Agenda Item # 9

SUB-002813-2024 & MOD-002814-2024

First Addition to, Resubdivision of, Paul Persons
Subdivision

Proposal:

DETAIL SITE PLAN

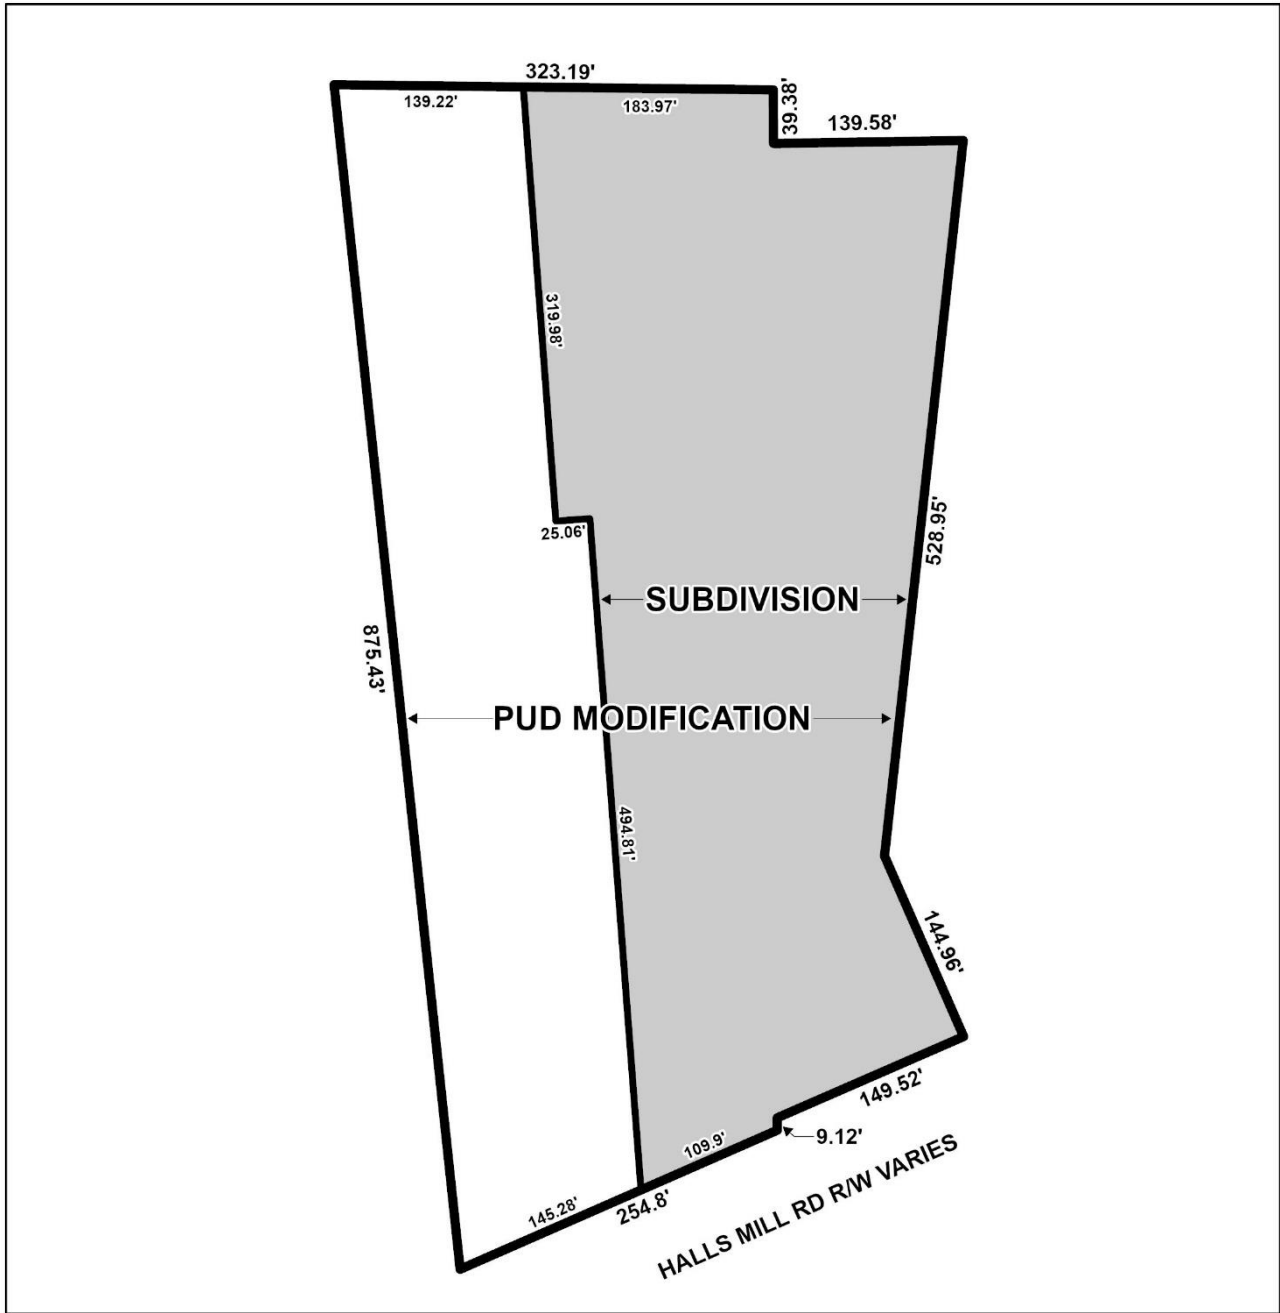
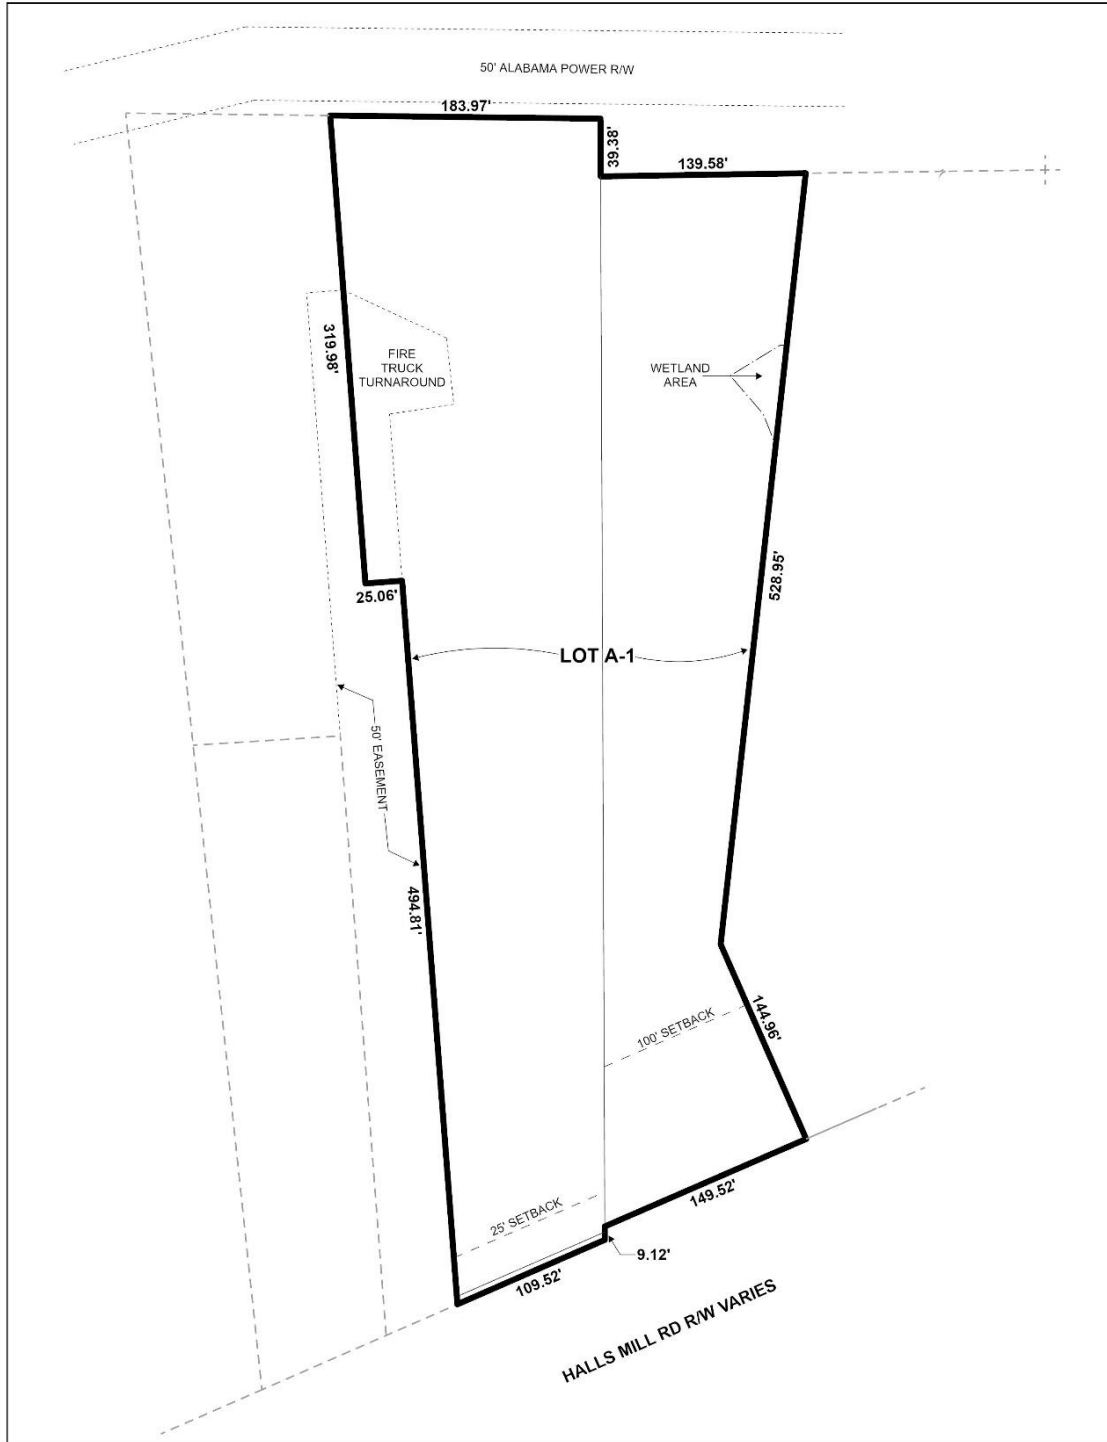
The site plan depicts new development of a portion of Lot A-1 of First Addition to, Resubdivision of, Paul Persons Subdivision for the purposes of expanding the existing use of a contracting business with storage yard. One (1) 7,200 square-foot building is proposed, as well as a 6,598± square-foot pole barn, along with a concrete sidewalk connecting the new building to existing parking.

The site plan reflects the changes proposed by the Subdivision request and illustrates the existing buildings and parking facilities, as well as proposed buildings and parking facilities. The applicant states in their justification of the request that the preliminary PUD site plan has been designed under the previous Zoning Ordinance standards. It should be noted, however, that as the proposed development (East half of proposed Lot A-1) was not included in any previous PUD approval, the new development must be designed in compliance with current standards as detailed in the Unified Development Code (UDC).

Off-street parking, tree planting, and landscaping is illustrated and calculations provided, however, the calculations were performed using the previous Zoning Ordinance. The Final PUD Site Plan should be revised to remove parking calculations and data as they are currently depicted, and provision of a note stating that all proposed and future development must comply with current code requirements should be required.

Two (2) bicycle parking spaces are required and must meet the standards of Section 64-3-12.A.9. Compliance with these requirements should be illustrated on a revised site plan.

Additionally, two (2) small off-street loading space are required per Section 64-3-12.B. and should be illustrated on the revised site plan.

No pedestrian walkway is illustrated connecting the building to a public sidewalk. The site needs to meet the pedestrian walkway requirements of Section 64-3-3 of Article 3 of the UDC.

The site plan illustrates a proposed 10-foot protection buffer where Lot A-1 abuts neighboring R-1, Single-Family Residential property. It should be noted that Section 64-3-8 of the UDC requires the 10-foot wide protection buffer to include both a wall or fence and screen planting where a B-3 zoned site abuts residential districts or a residentially used building site. As such, the Final PUD Site Plan should be revised to include a note stating as such.

An existing dumpster enclosure is illustrated on the site plan. Nevertheless, a note should be placed on the site plan stating any dumpster placed on the property must meet the enclosure and placement standards of Section 64-3-13.A.4. of the UDC.

The site plan illustrates multiple easements on the subject site. These easements should be retained on the Final PUD Site Plan, if approved, with provision of a note stating that no structure shall be constructed in any easement without permission of the easement holder.

- 3. Placement of a note on the Final PUD Site Plan stating that, upon development of the site, as proposed, the entirety of Lot A-1 must comply with current UDC Landscaping & Tree standards as detailed in Article 3 Section 64-3-7 of the Unified Development Code;

- 4. Revision of the Final PUD Site Plan to remove Tree Planting, Landscaping, and Parking data and calculations as they are currently depicted;
- 5. Provision of a note stating that all proposed and future development must comply with current UDC requirements;

- 6. Revision of the Final PUD Site Plan such that notes referencing sections from the previous Zoning Ordinance are updated to their corresponding Sections in the Unified Development Code;

- 7. Revision of the site plan to illustrate compliance with the bicycle parking standards of Section 64-3-12.A.9;
- 8. Revision of the site plan to illustrate compliance with the off-street loading facilities standards of Section 64-3-12.B;

- 9. Revision of the site plan to illustrate compliance with the on-site pedestrian safety standards of Section 64-3-3;
- 10. Provision of a revised tree and landscape plan at the time of permitting illustrating compliance with the City Council's decision, or in compliance with Section 64-3-7;

- 11. Provision of a note on the site plan stating any dumpster placed on the property must meet the enclosure and placement standards of Section 64-3-13.A.4. of the UDC;

- 12. Provision of a note on the site plan stating that all proposed and future protection buffers must comply with Section 64-3-8 of the UDC;
- 13. Retention of all easements, as illustrated;

- 14. Provision of a note on the site plan stating no structures shall be constructed in any easement without permission from the easement holder;
